Product Change Notification

Change Notification #: 112338 - 00
Change Title: Intel® Server System P4308CP4MHEN
PCN 112338-00, Product Design, Label
Update BIOS/BMC/ME Firmware, Server
Side Cover and Package Regulatory Label
with Perchlorate Statement
Date of Publication: June 12, 2013

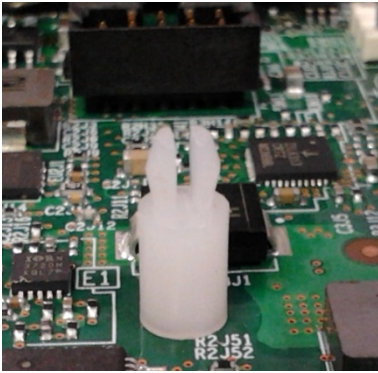
4. A plastic stand-off will be pre-installed on the server board. Users can install an eUSB SSD device on the stand-off.

The picture below shows the stand-off pre-installed on the server board:

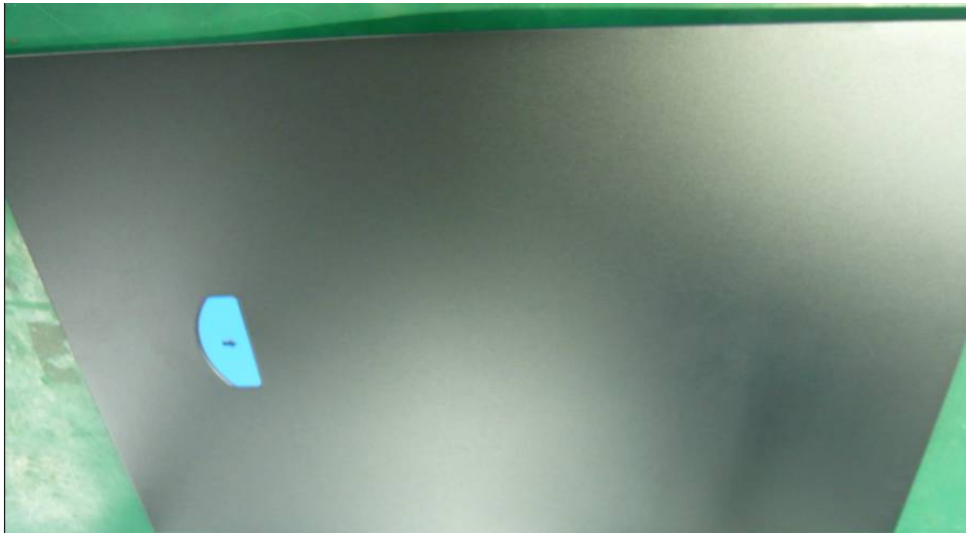
5. A side cover handle will be added to improve the ease of cover removal. See the Post change pictures below for an illustration of the change.

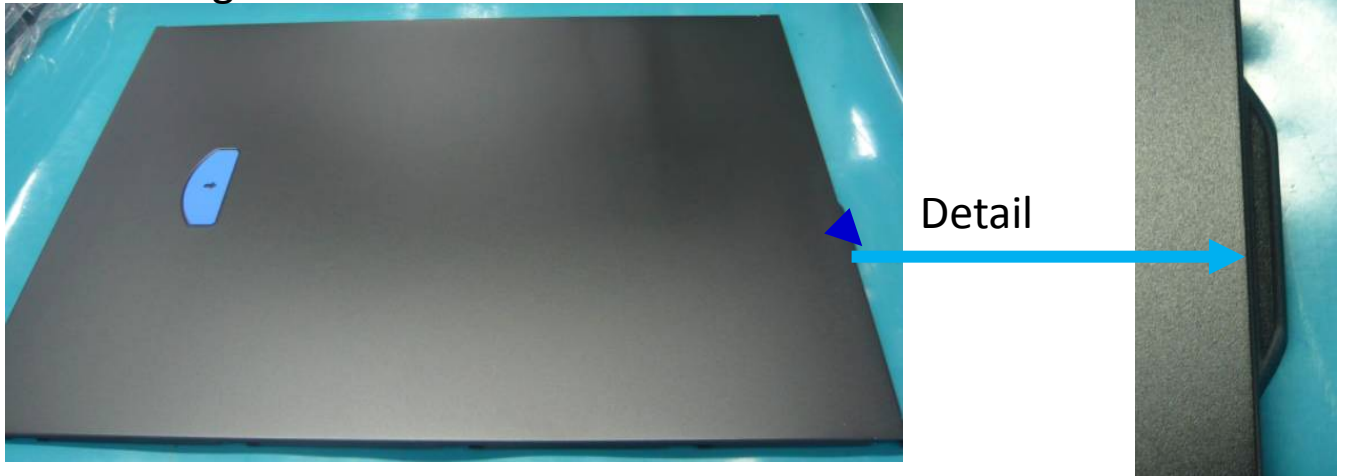
6. As part of Intel's efforts in environmental responsibility to eliminate excess materials for disposal, Intel will no longer be including the piece of paper with the California PERCHLORATE notification. Instead Intel will be including the California PERCHLORATE notification on an existing safety label. See below picture. See below picture:
